Enclosure
L-18-016

Perry Nuclear Power Plant EP 0000 Revision 52 Change Summary

TITLE: EMERGENCY PLAN FOR PERRY NUCLEAR POWER PLANT DOCKET NOS. 50-440

REVISION: 52 EFFECTIVE DATE: 12-21-17

FIGURE 6-1 - EMERGENCY NOTIFICATION

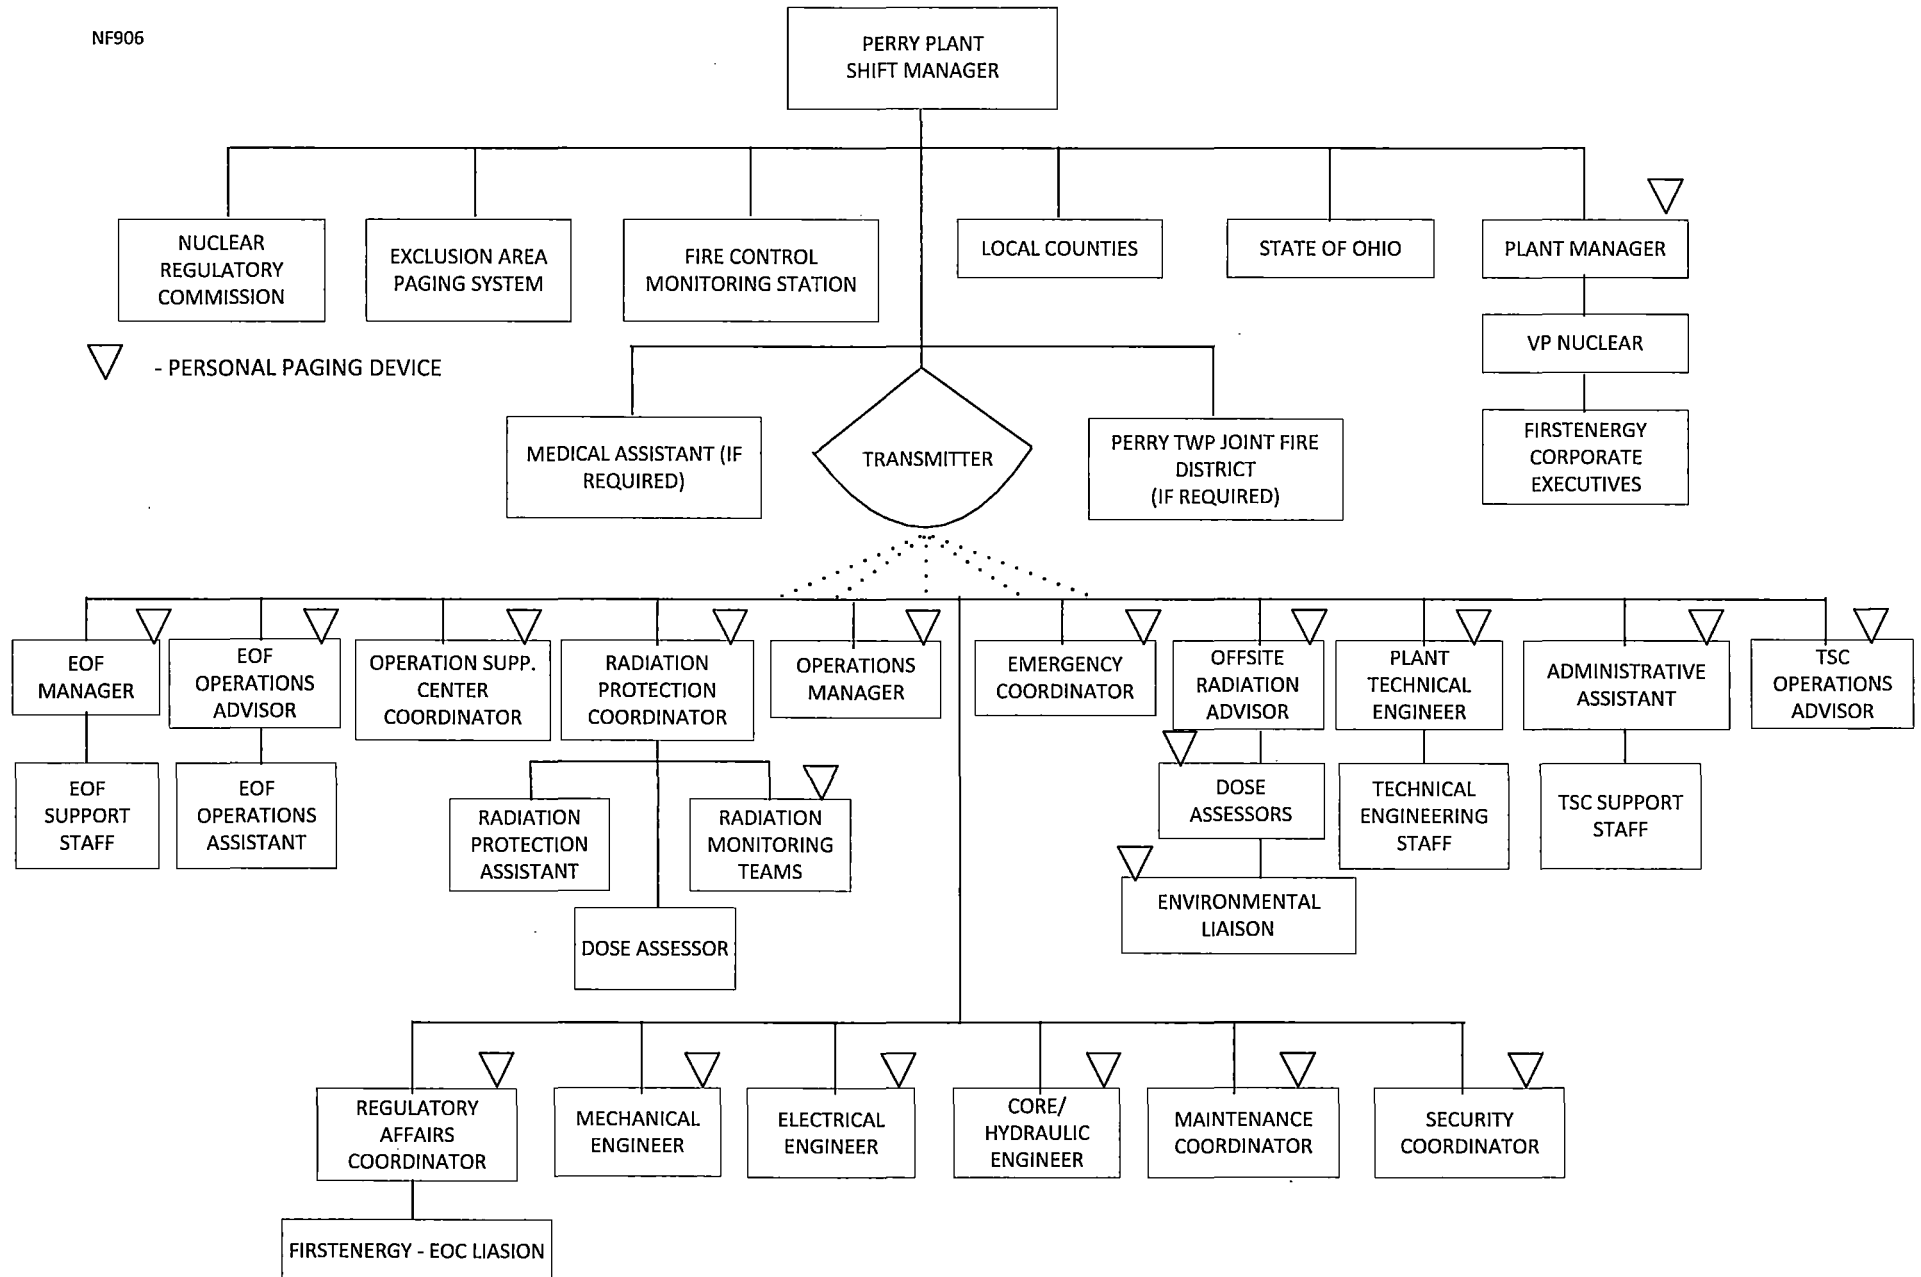
16. Appendix A - Replaced SPI-0032 with PYBP-ERS-0037, Notification of Key Plant Personnel.
 17. Figure 6.1 - Replaced Secondary Alarm Station Operation with Fire Control Monitoring Station.
